You will find enclosed a copy of Service Bulletin S07LN regarding the routing of the alternator power cable on your Blue Bird All American model bus(es).

# Alternator Cable Routing

MODELS AFFECTED: 2007 A3FE All American

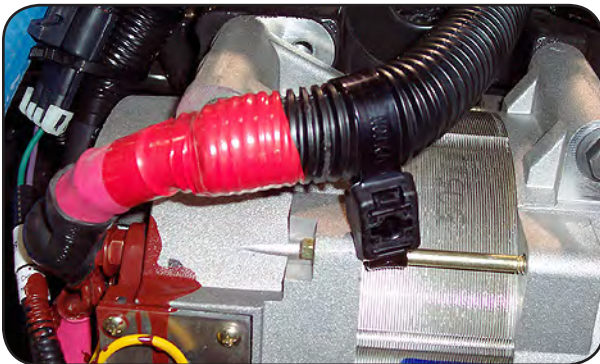
The positive battery cable leading from the rear of the alternator to the Power Distribution Unit (PDU) may contact the charge air cooler tube.

*Before: Cable contacting CAC tube.*

*After: Cable secured to prevent contact with CAC tube.*

4.1 With the terminal nut which secures the battery power cable to the back of the alternator loose, press the cable toward the right side of the alternator. Secure in place using the dual cable tie assembly looped around the cable and the bolt shaft of the alternator.

4.2 Tighten the connector nut to 17-22 ft lb.
